Ordinary Council Meeting - 22 August 2023 Attachments

4.1 DA2023/00055 - 1100 COLES BAY RD, COLES BAY - VISITOR ACCOMMODATION, CAFE, CELLAR	
DOOR AND DWELLING.....	2
4.1.1 Revised Plans - DA 2023/00055.....	2

PROPOSED RESIDENCE, CABINS AND CELLAR DOOR 1100 COLES BAY ROAD COLES BAY

LOCATION PLAN
1:5000

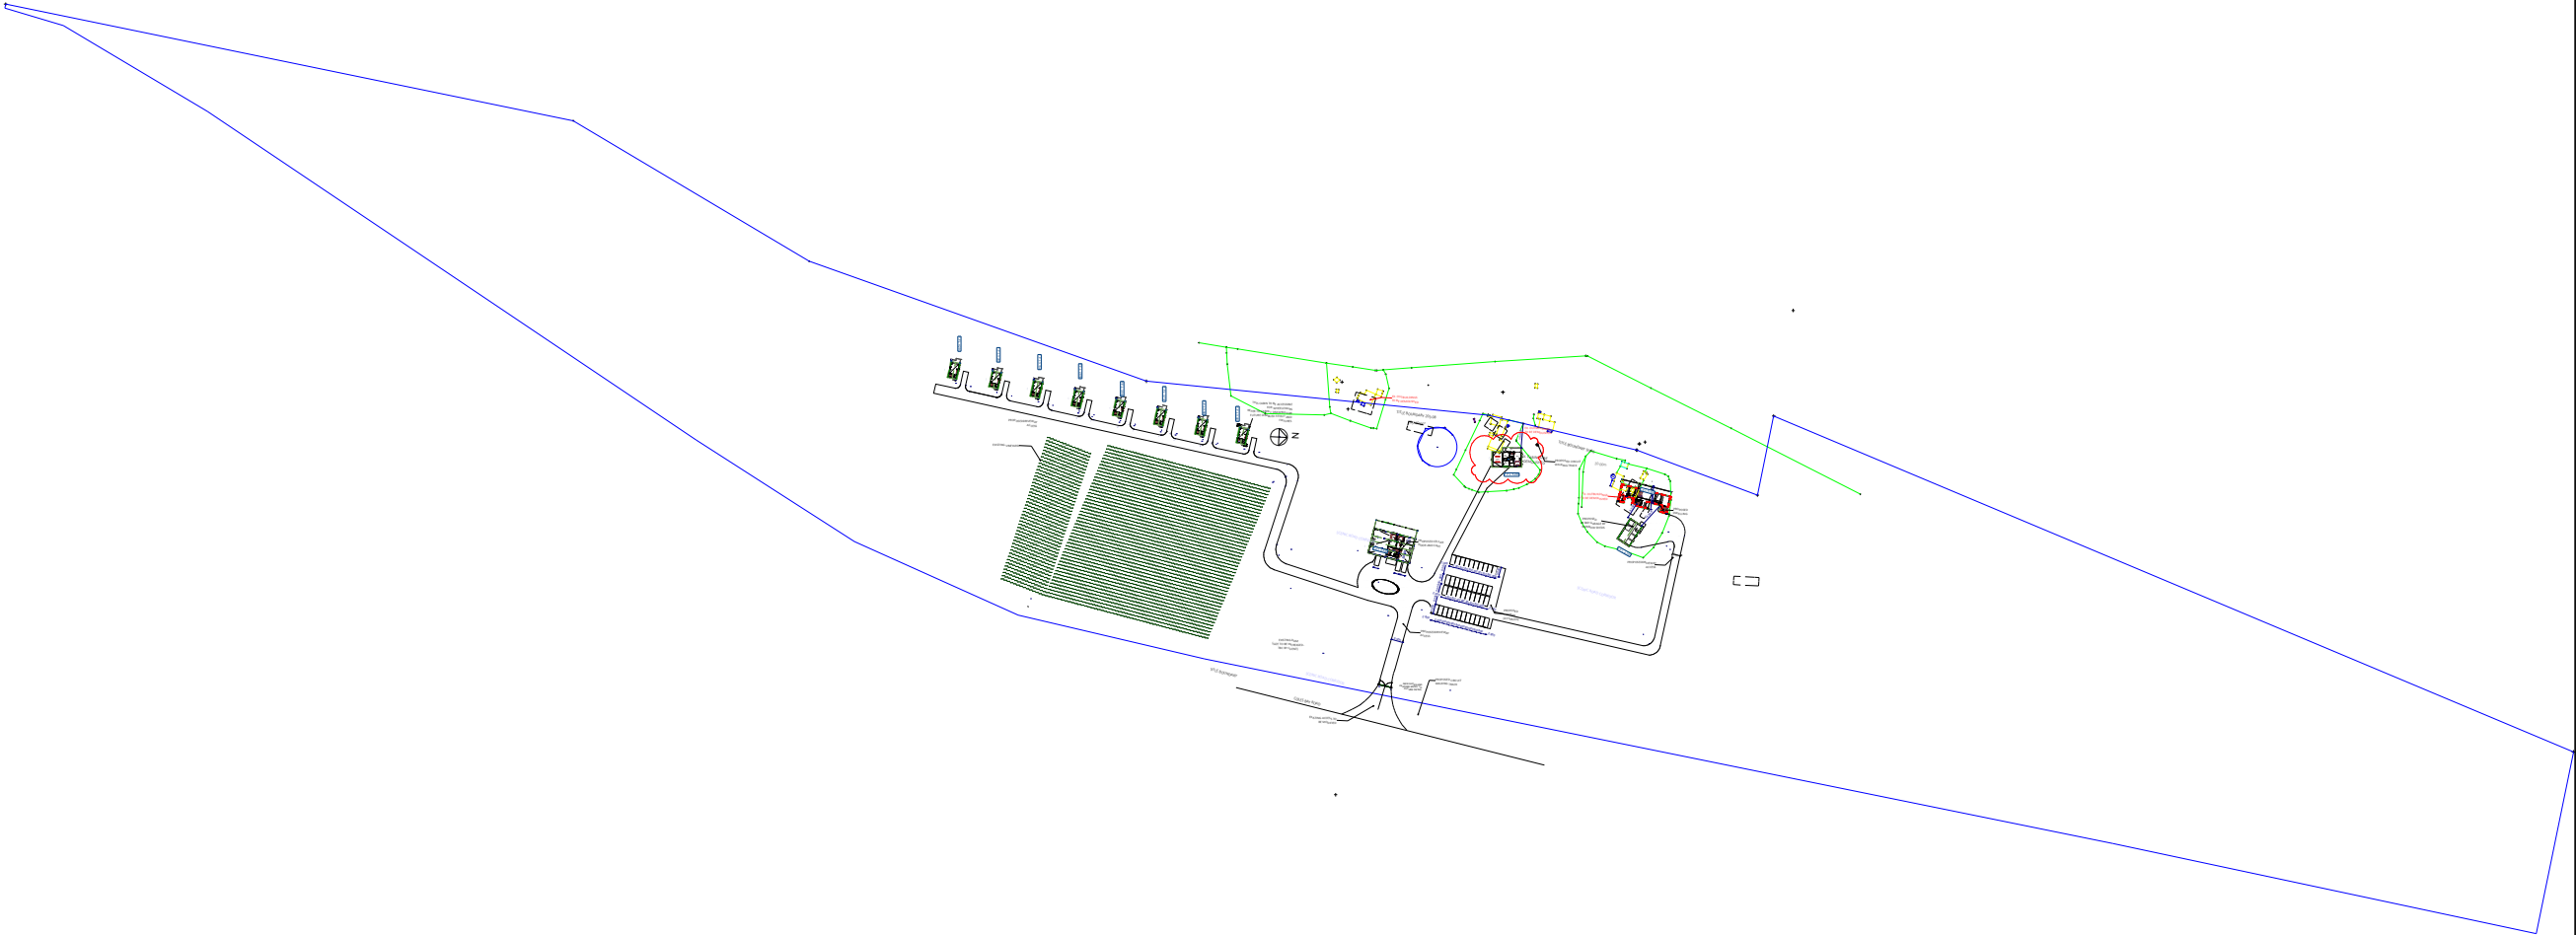
The plans as advertised show a proposed dwelling, garage, eight (8) cabins, a café, carparking, as well as demolition (Location Plan, Sheet A02, Revision B, dated 30/5/23).

Five (5) structures are annotated with "Ex. Outbuildings to be demolished" (Location Plan). The Location Plan shows two (2) of these buildings outside the site boundary and partially on the Game Reserve, as well as three (3) close to and inside the property boundary. However, the Drainage Plan (29/10/2022, Sheet A08) in contradiction, appears to show two of the latter structures partially on the Game Reserve in that plan.

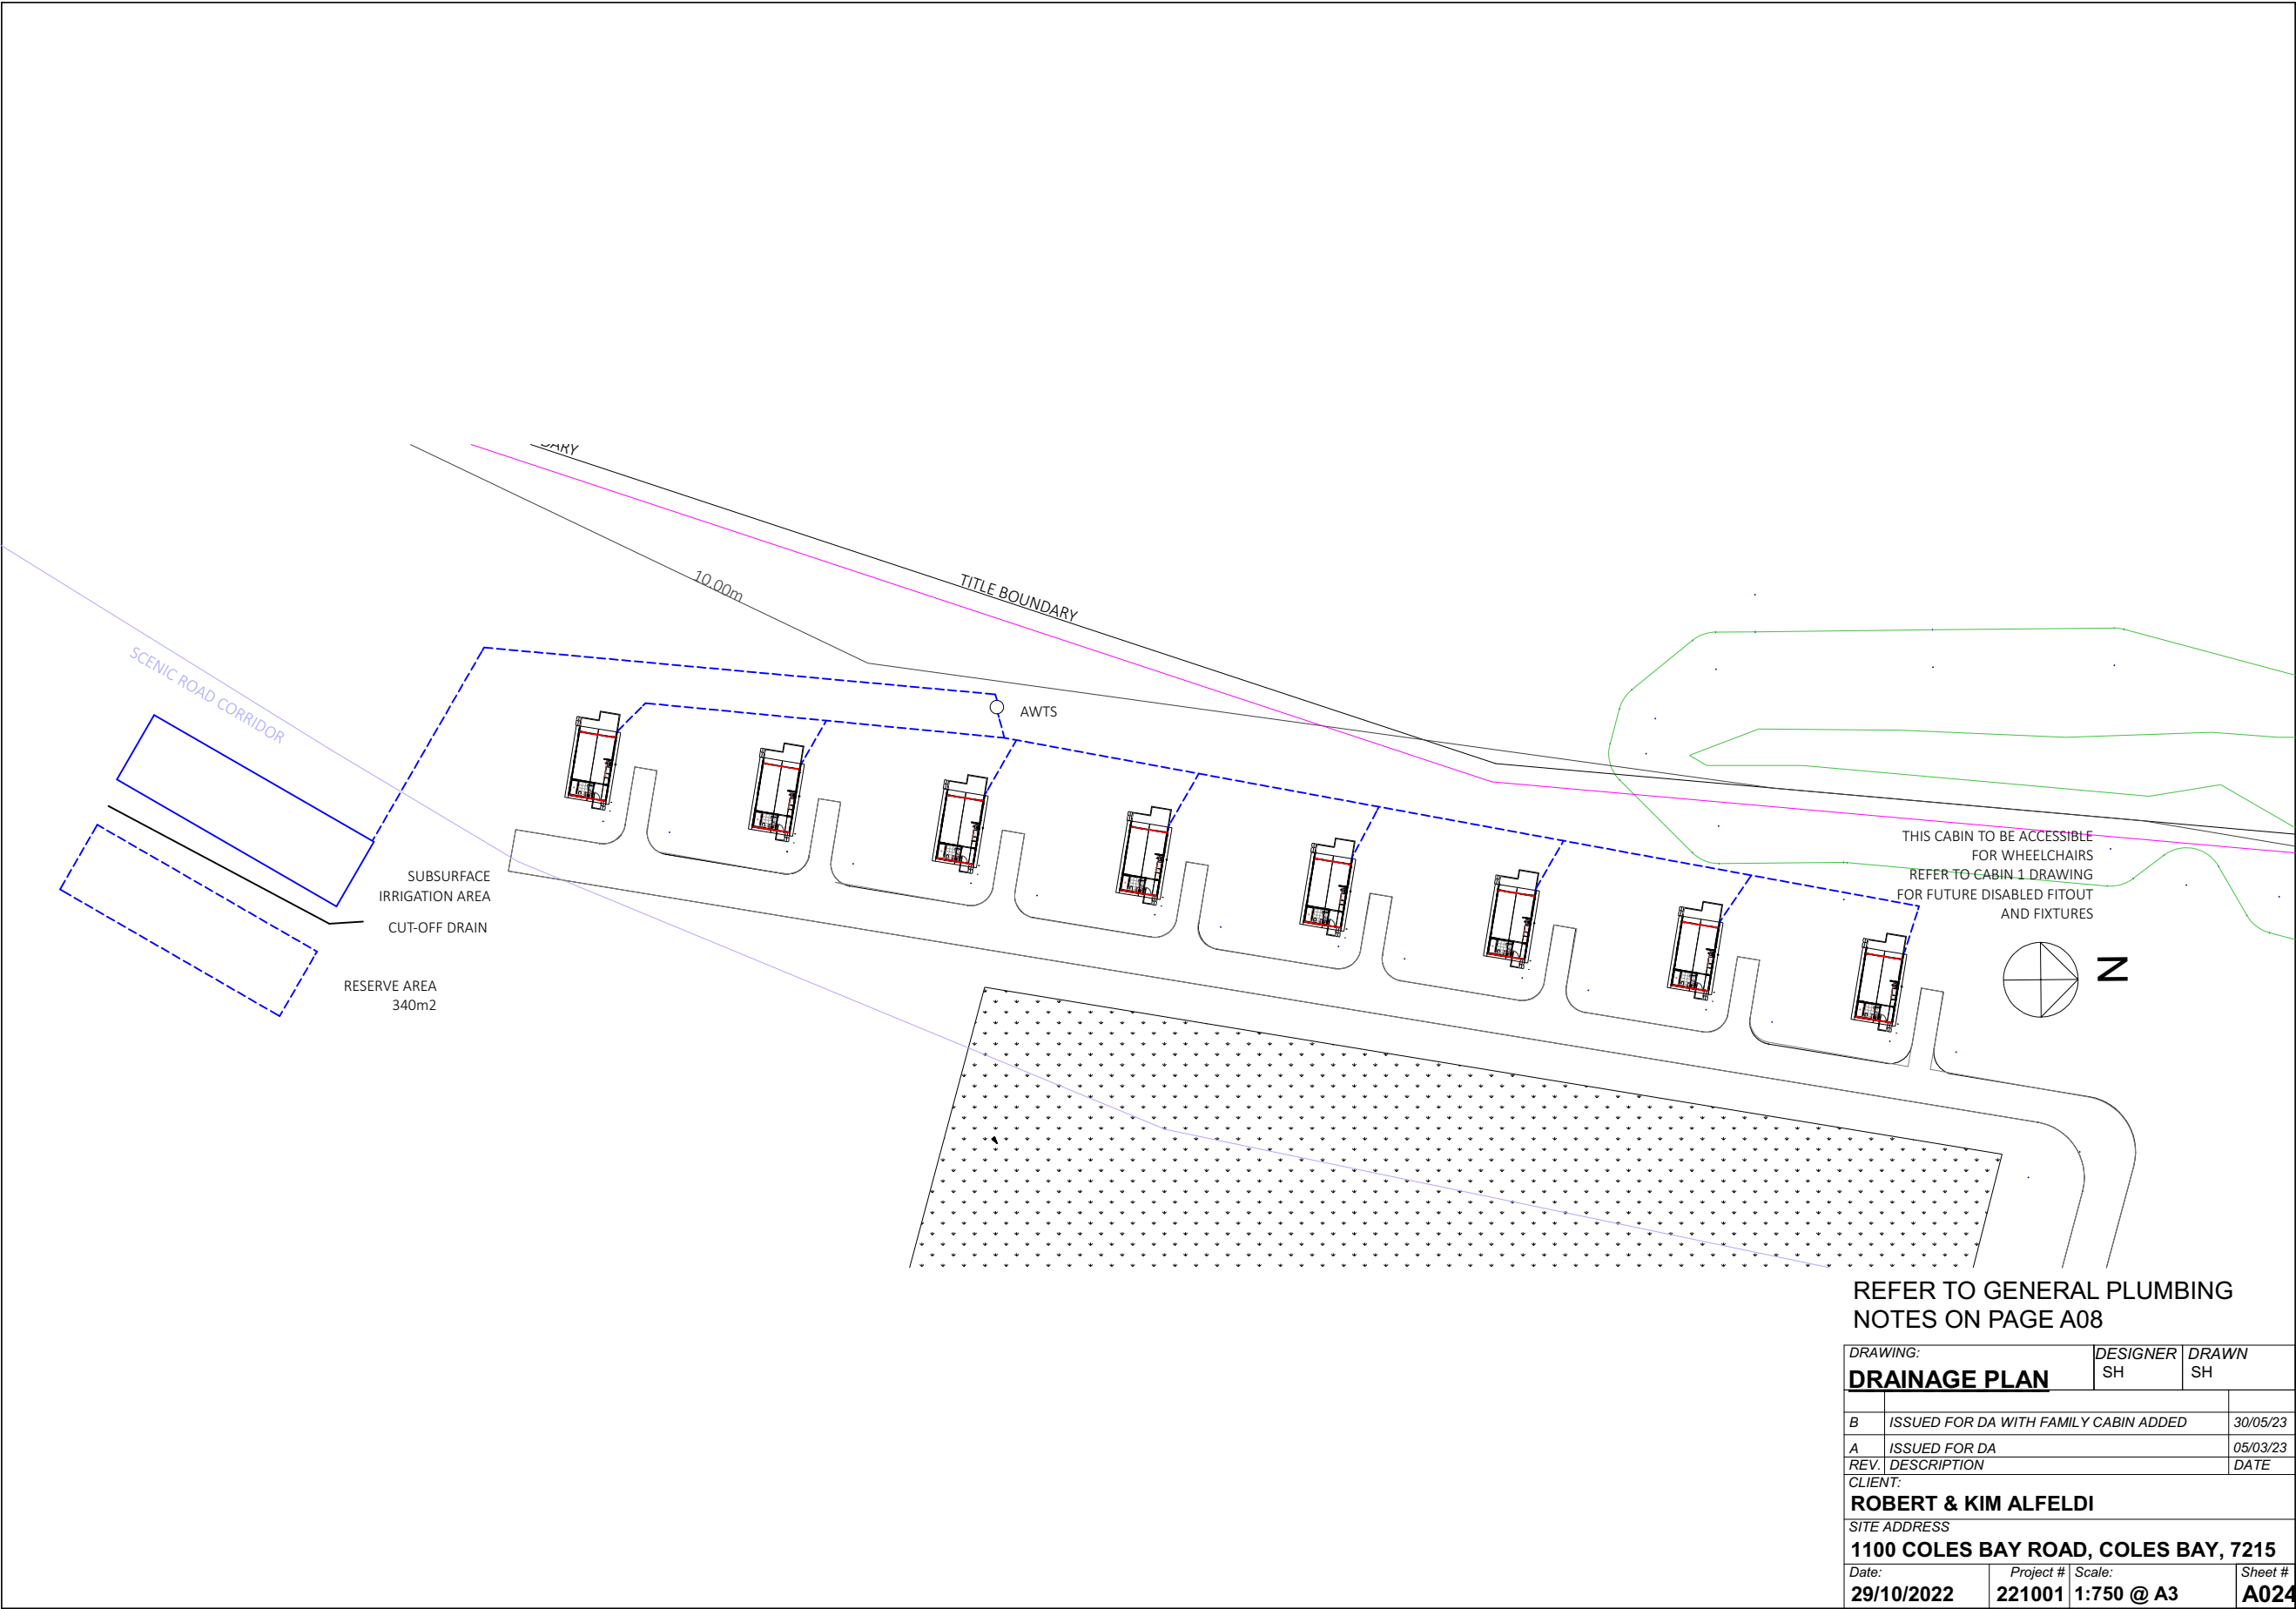
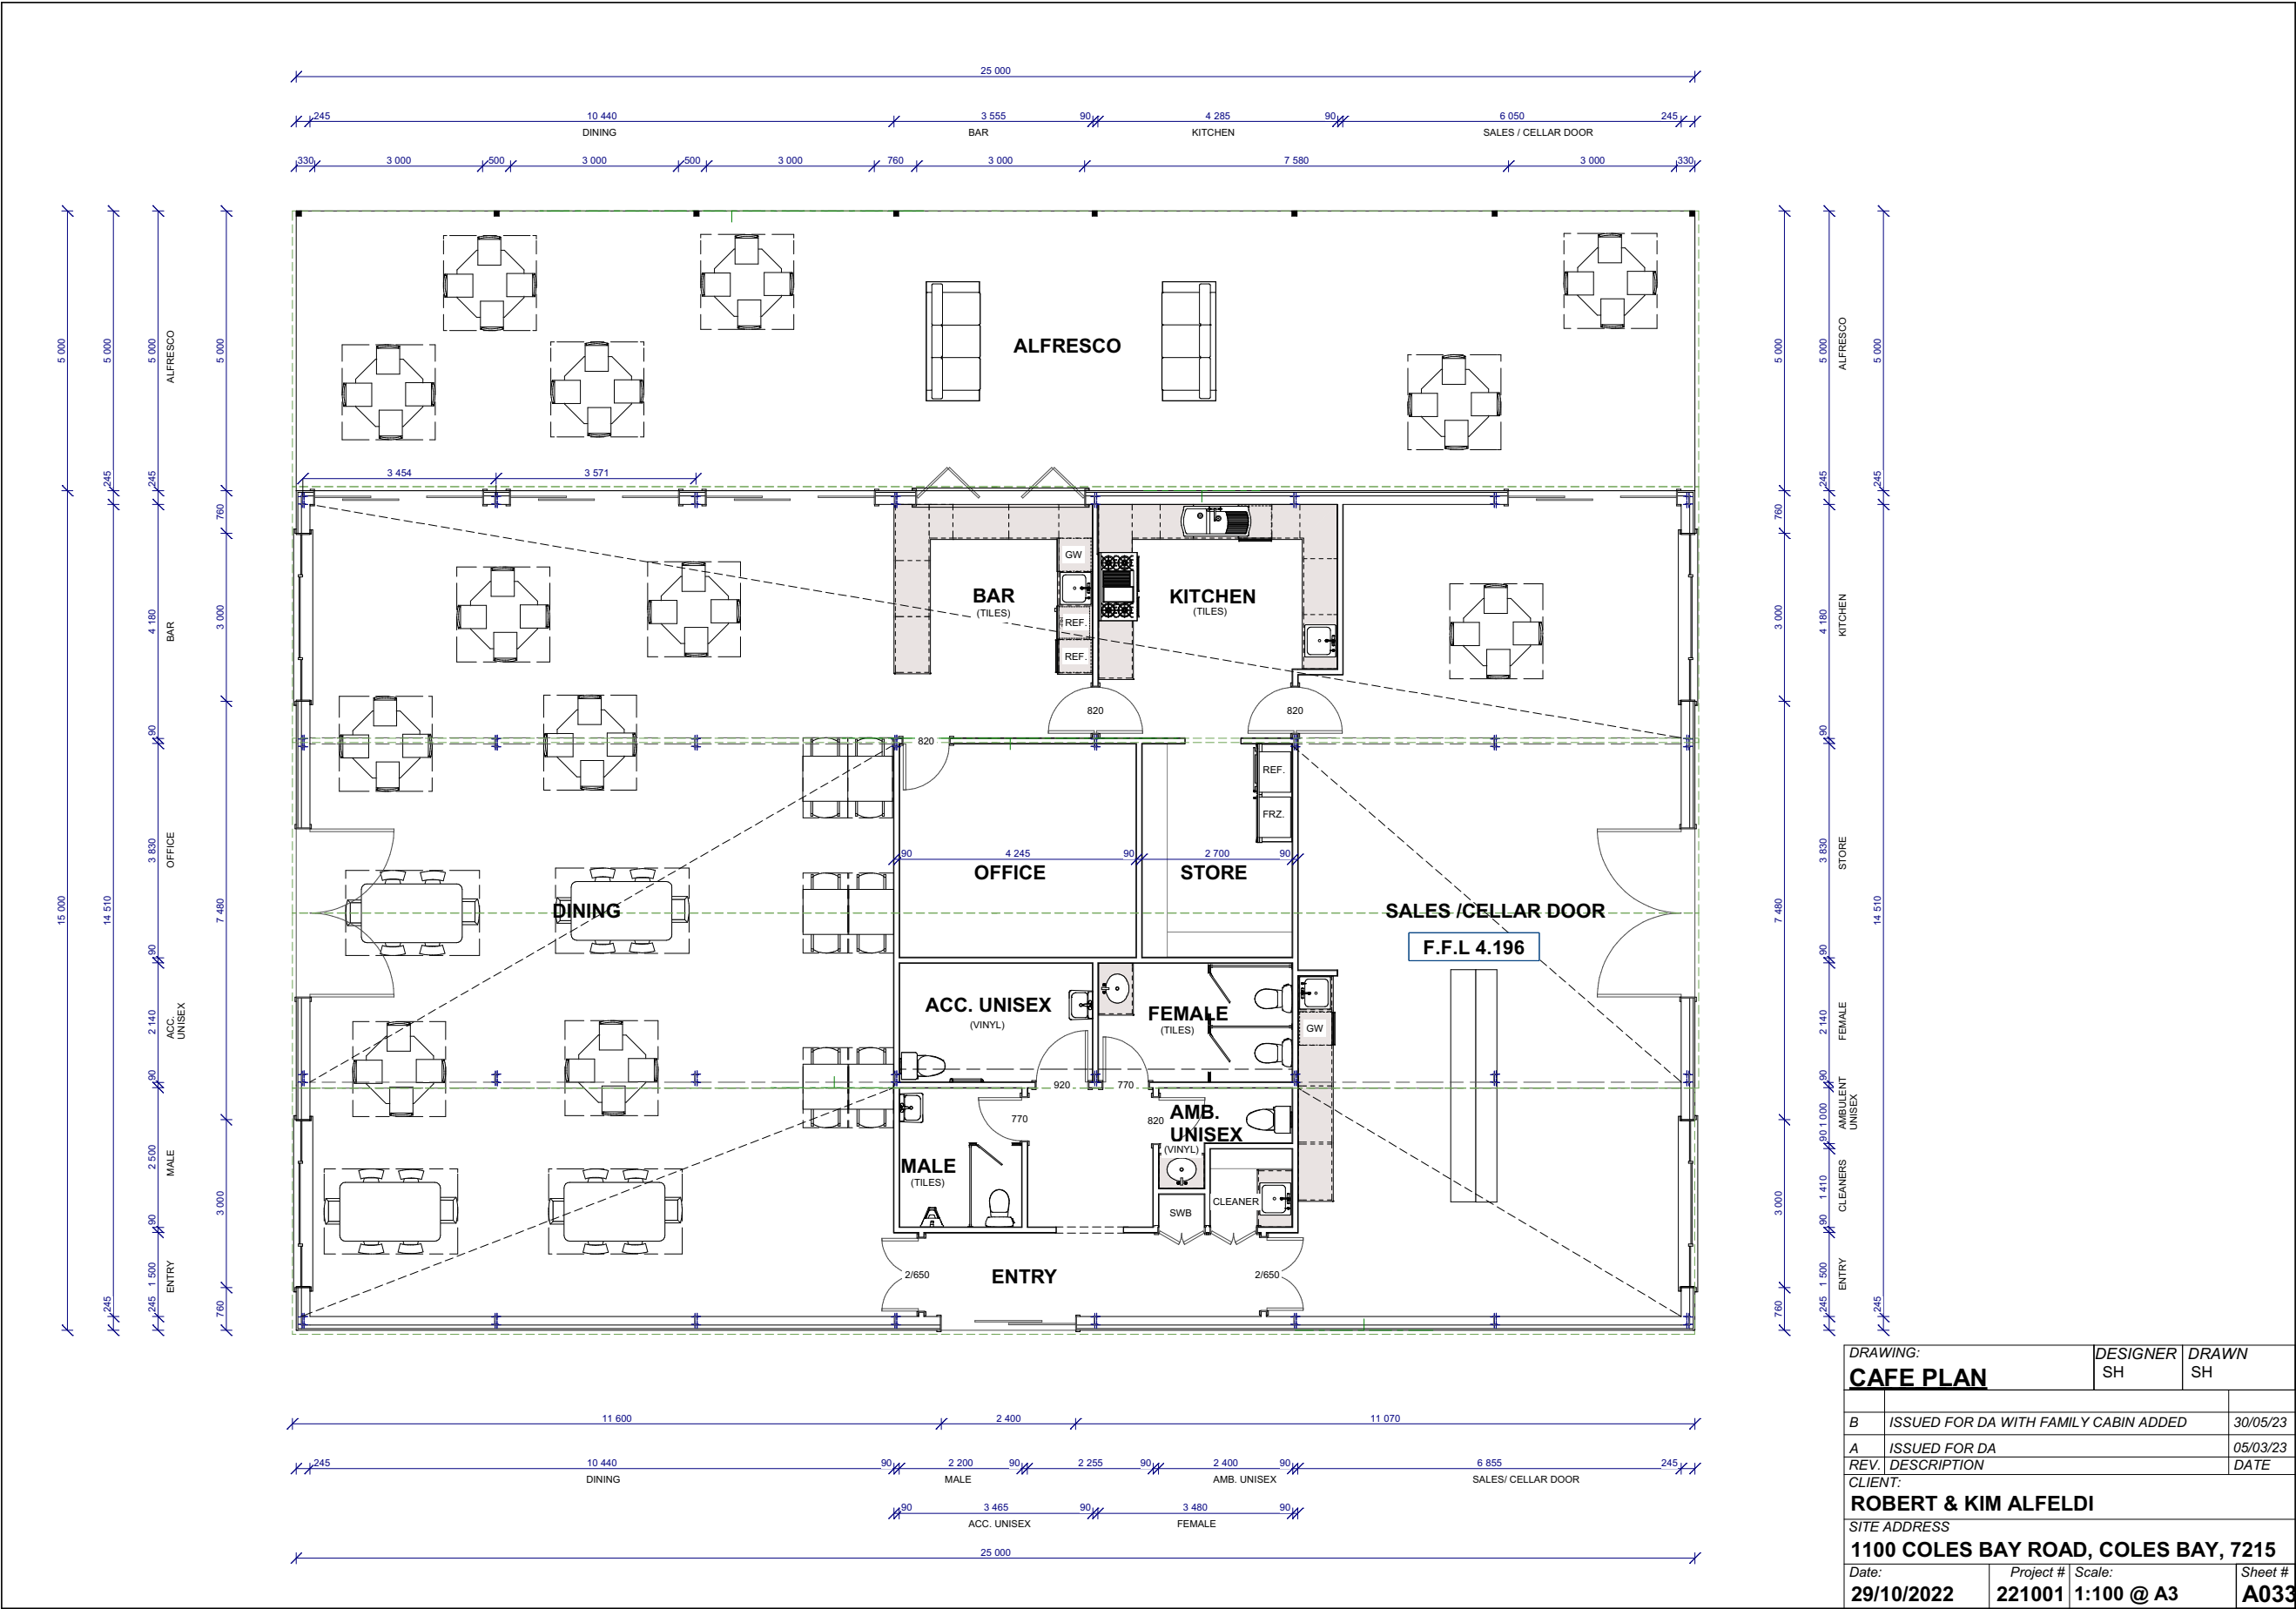
It is uncertain (Cabin Elevations, 30/5/23, A020) adjacent to the reserve are proposed to have the same finishes. The 'Cabin Elevations' plans show roof, cladding and windows annotated with "Custom orb roof sheet Colourbond finish to clients' requirements", "cladding painted finish to clients' requirements" and "powder coated sliding doors colour to clients requirements". PWS would request that to support the objective of C7.6.1, that similarly low reflectance external finishes, and low-reflectance glass treatment, is applied to the cabins, being approximately 5-10m (no distance annotated) from the boundary with the Moulting Lagoon Game Reserve.
